TITLE: USE PERMIT NO. 152, Pioneer Pointe Plaza, requested by Brian D. Carstens and Associates on behalf of John, Janice and Gary VerMaas, for 49,900 square feet of medical, financial and office floor area, with associated waiver requests, on property generally located northeast of the intersection of Pioneers Blvd. and Highway 2.

LINCOLN CITY/LANCASTER COUNTY PLANNING STAFF REPORT

P.A.S.: Change of Zone #3414 - from P to O-3
Use Permit 152 - Pioneer Pointe Plaza

To: Brian Will, Planning Department
From: Chad Blahak, Public Works and Utilities
Subject: Pioneer Pointe Plaza Use Permit #152
Date: 7/09/03
cc: Randy Hoskins
Devin Biesecker

UTILITY PLAN

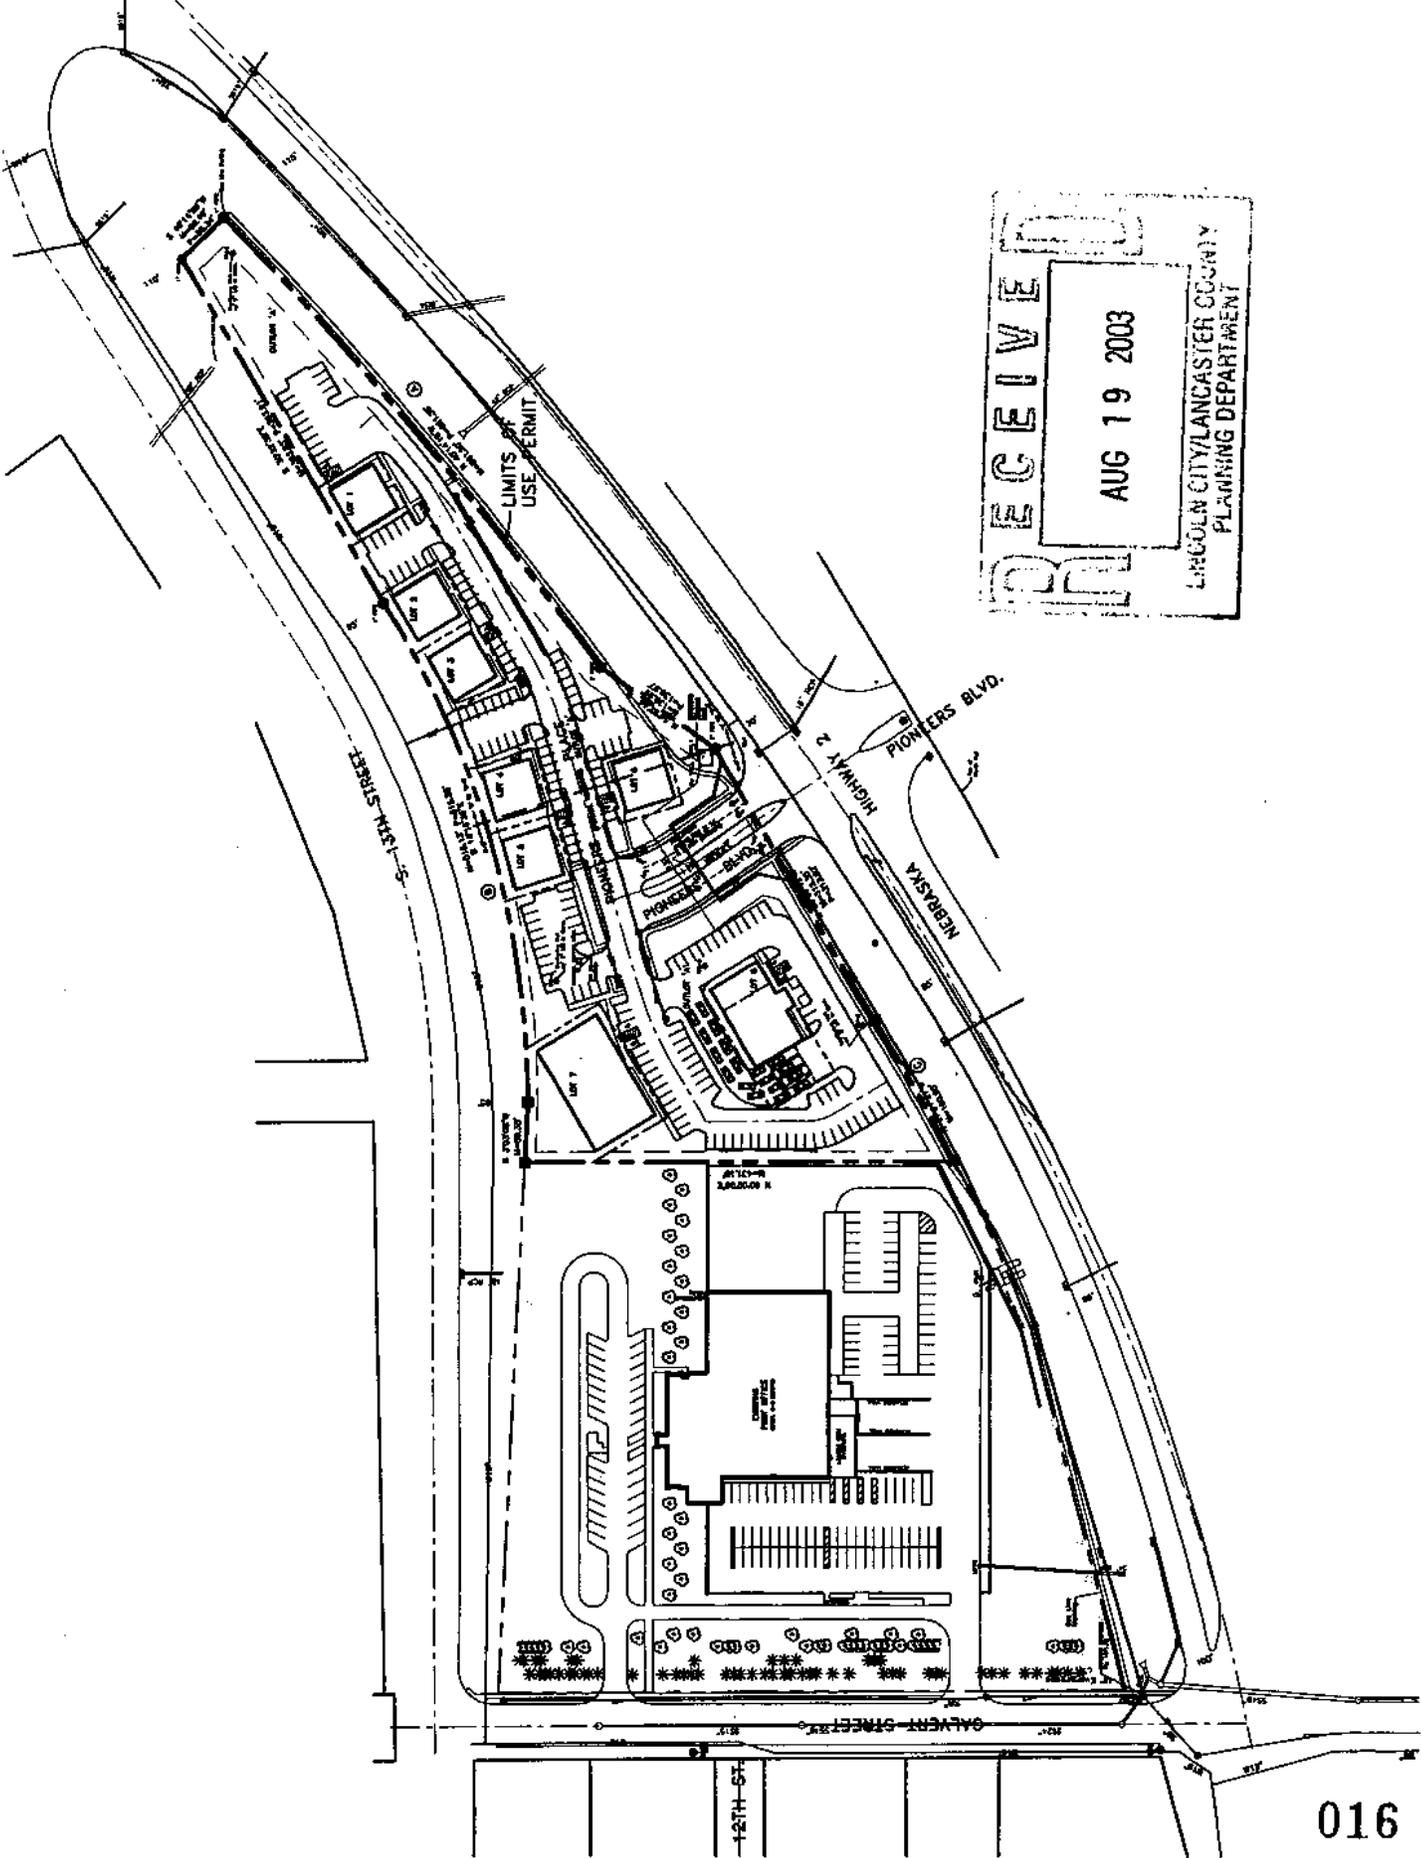
Sanitary - The sanitary system is satisfactory contingent on the NDOR's review and approval of the use of its right of way for sanitary sewer construction.

A waiver for running sanitary sewer opposite street grade needs to be requested for sewer in Pioneers Place. Public works would support this waiver provided that sewer depth stays under the maximum 15' as per design standards.

LANDSCAPE PLAN

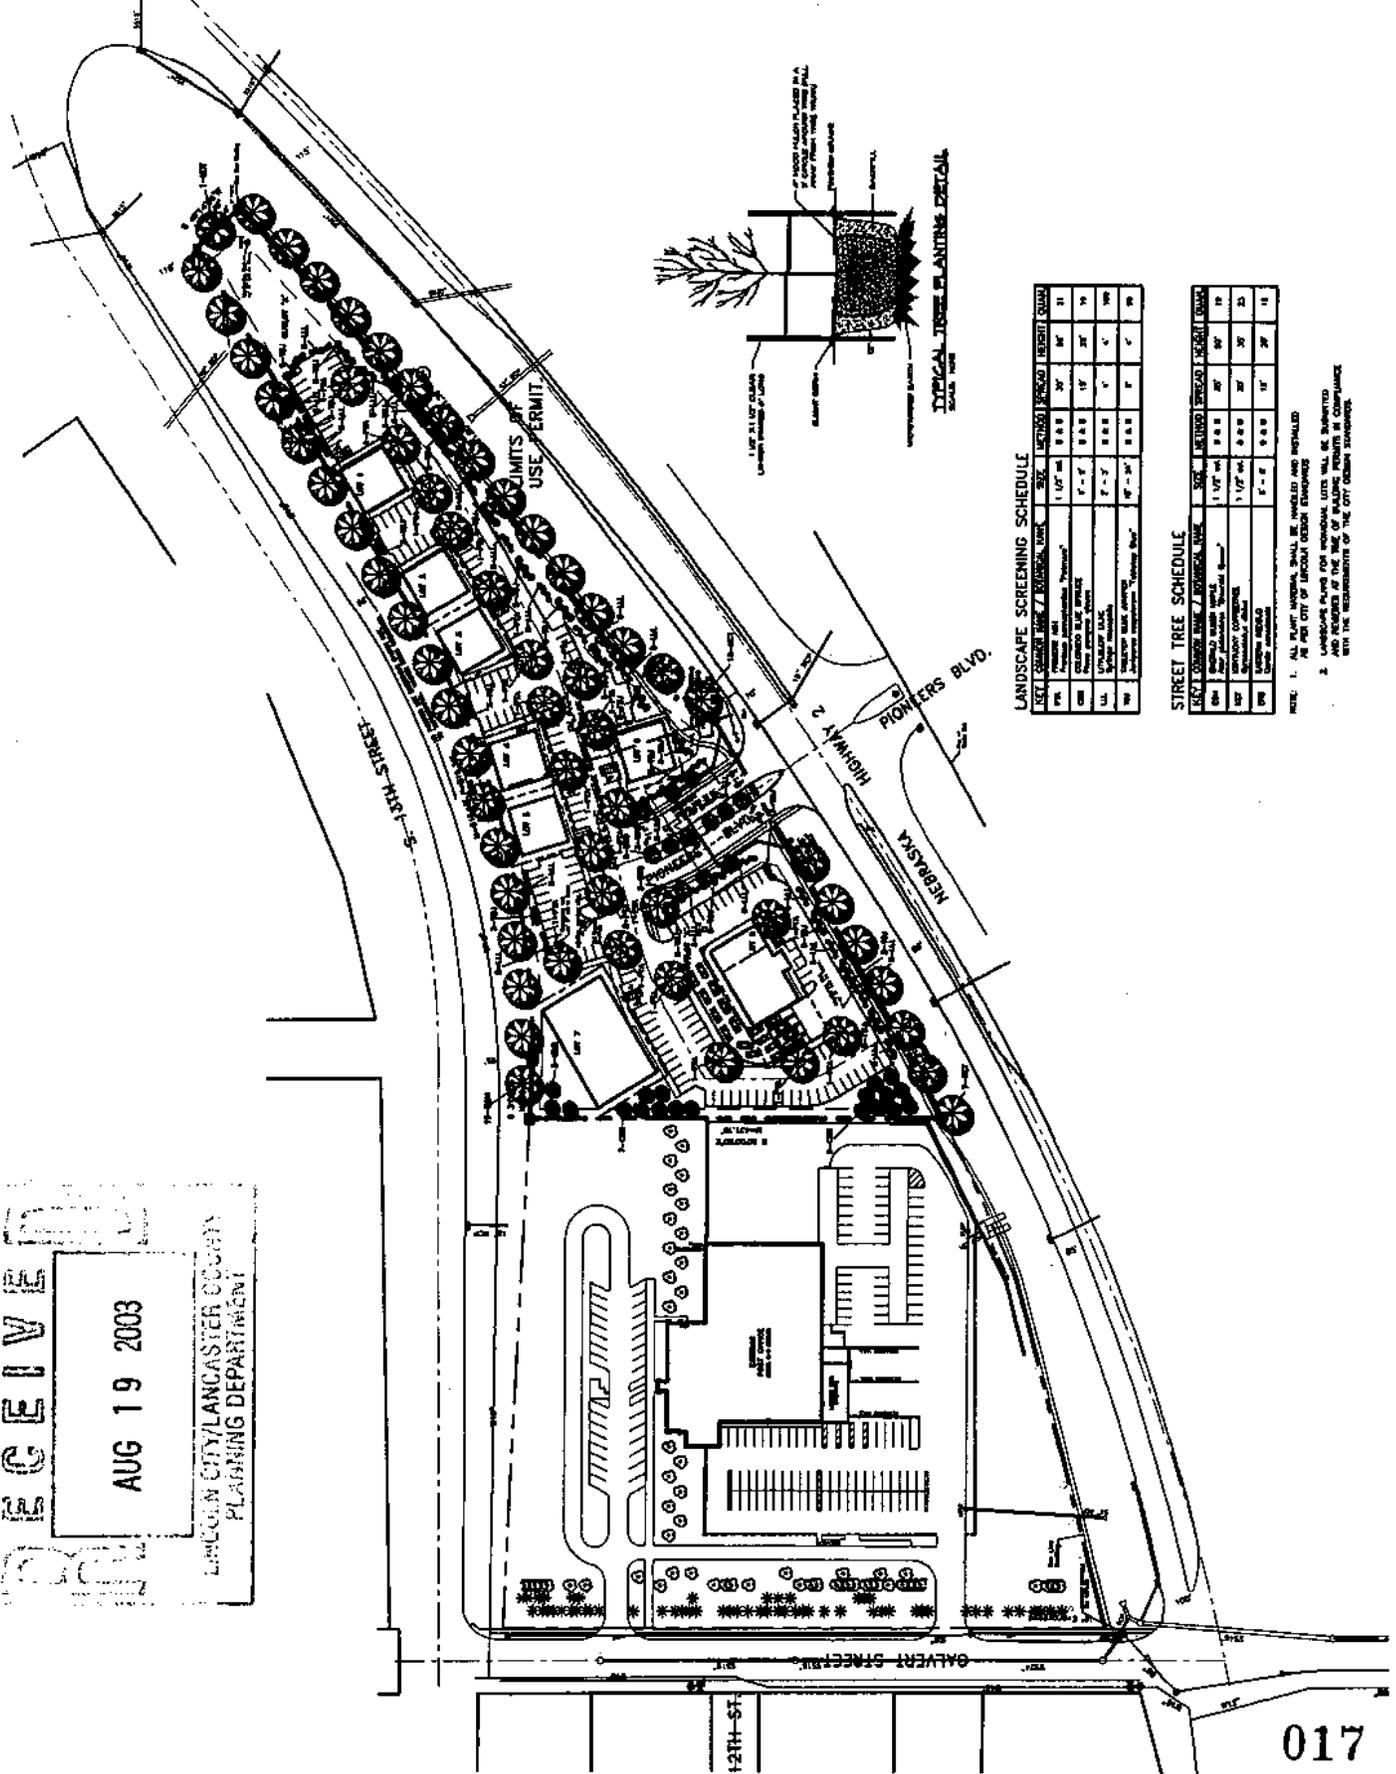
13. The landscape plan shows two sign envelopes for 8' high signs, 32 square feet in area. Only one sign envelope of this size for office park identification is allowed in the O-3 district. The sign envelope on Lot 8 must be removed as it exceeds what is allowed by the district; the other sign envelope is designated as an identification sign for the development and is allowed, but the location of the envelope must be clearly delineated.

- 1.1.6.1 Kentucky Coffeetree as the street tree along Highway 2, and that substitutes Autumn Blaze Maple for Emerald Queen Maple.
 - 1.1.6.2 Additional trees at the drive entrance to the development, at the south end of Outlot A, and along the east boundary and in the parking lots.

- 1.1.6.3 The sign envelope for the 32 square foot, 8' high sign on Lot 8 deleted, and the remaining center identification sign envelope clearly identified.

1. Please provide a graded platform for a 10" trail with a 20' trail easement.
2. It is recommended that the trail/trail easement parallel the property line on private property as much as possible.
3. Please use Kentucky Coffeetree as street tree along Highway 2.
4. Emerald Queen Maple struggles during establishment period. Please consider using Autumn Blaze Maple as an alternative.

**GRADING
 PLAN**

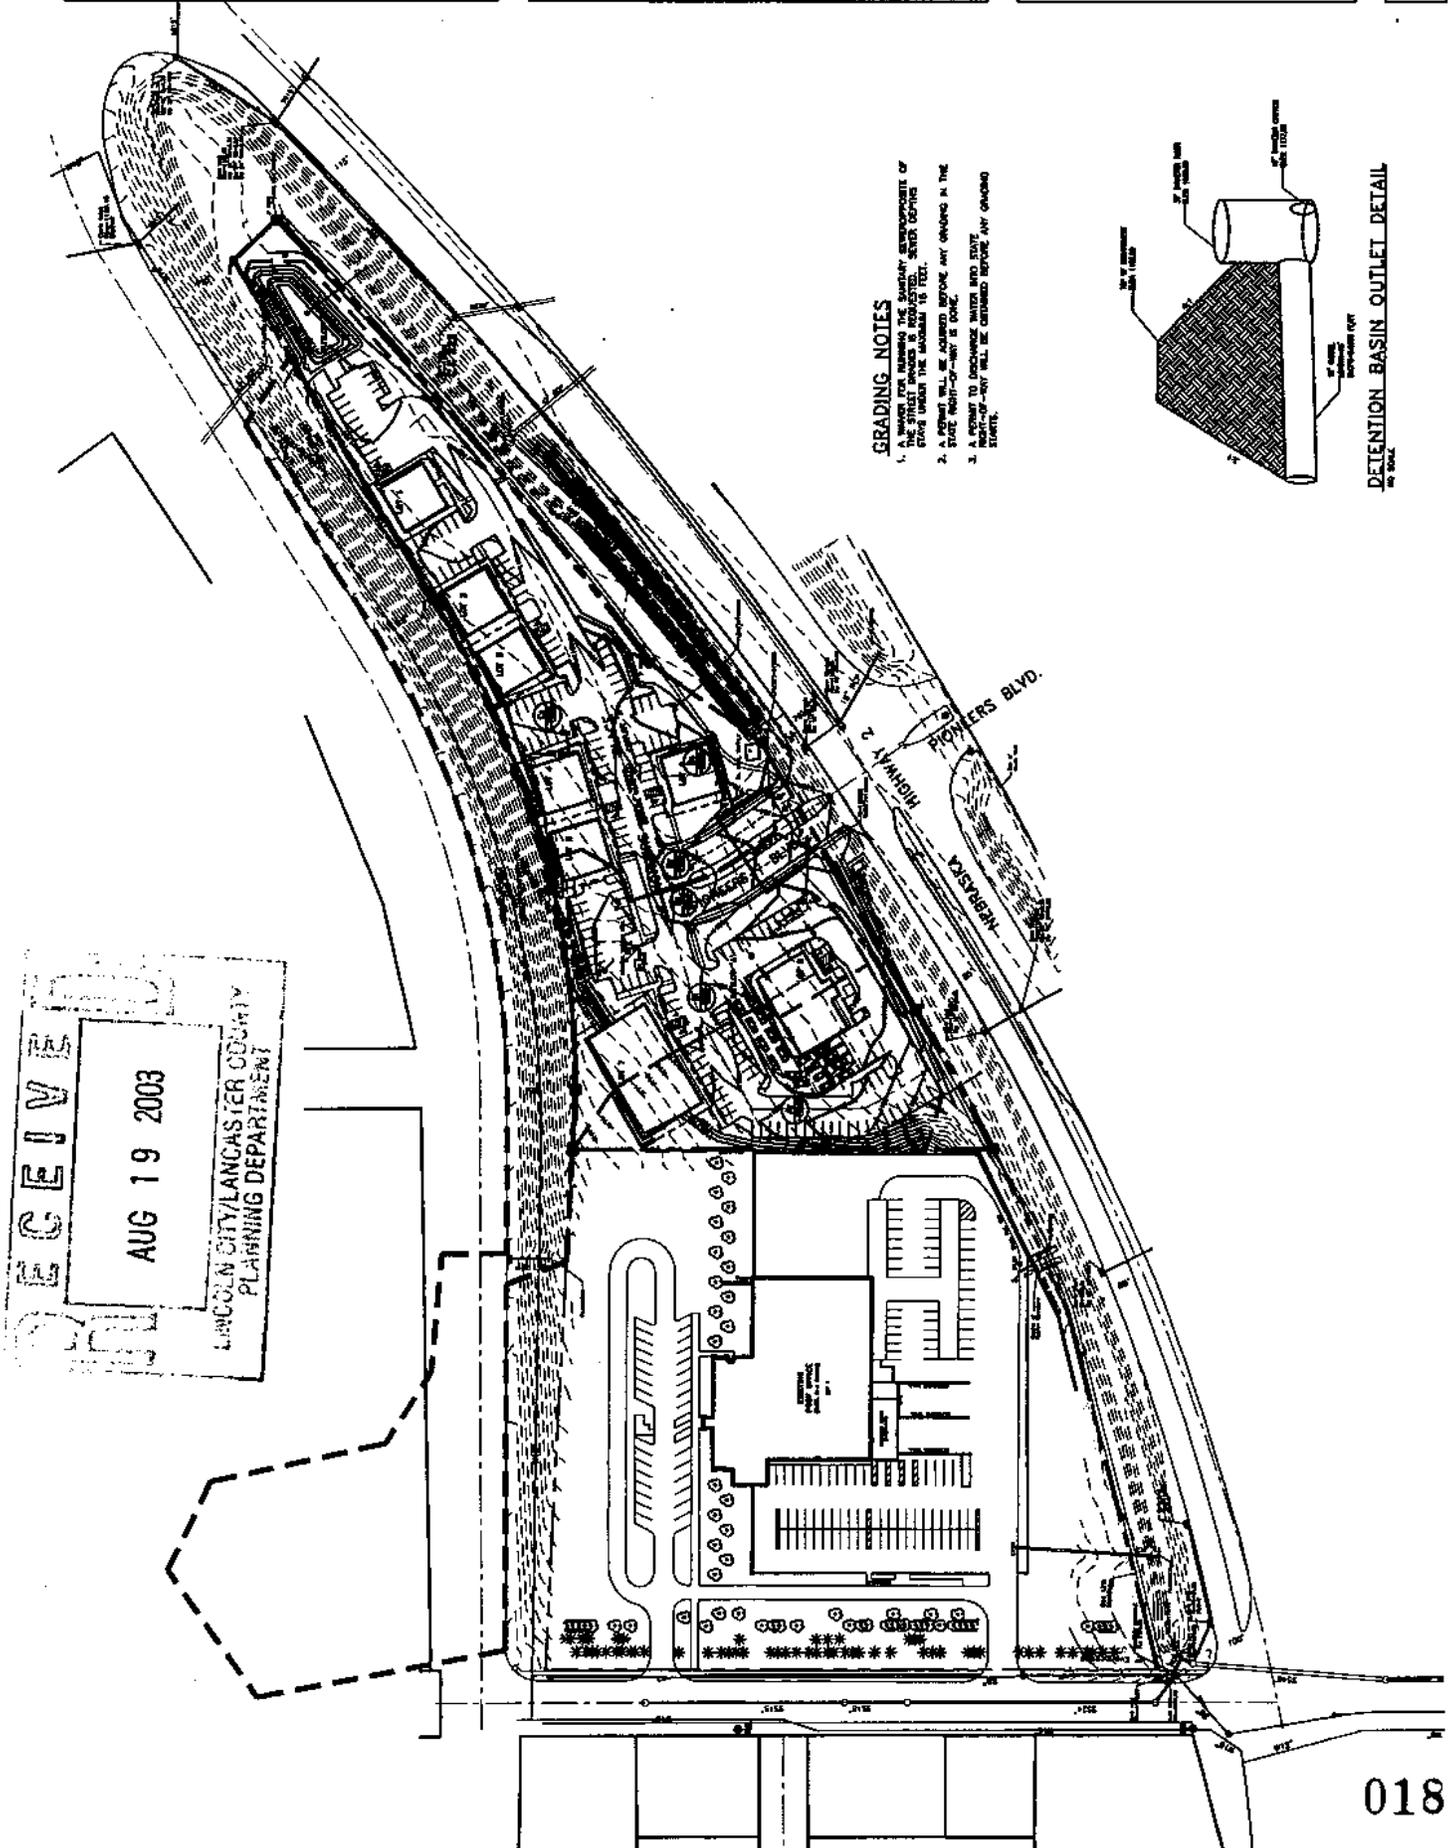
Grading/Drainage - Grading is shown outside of the property line inside the NDOR right of way. State approval will have to be obtained in order to conduct grading activities in the right of way.

The proposed detention cell is located directly in front of an outlet for an existing 42" storm sewer. The proximity of the 42" outlet to the bank fo the cell velocities for the 42" outlet should be calculated and energy dissipation and/or bank stabilization measures will be required if the velocities prove to be erosive.

The letter accompanying the application stated a requested waiver for street cross section, specifically eliminating the roadway crown. The grading plan shows a crowned section the entire length of the roadway. If this is the case the waiver is not needed.
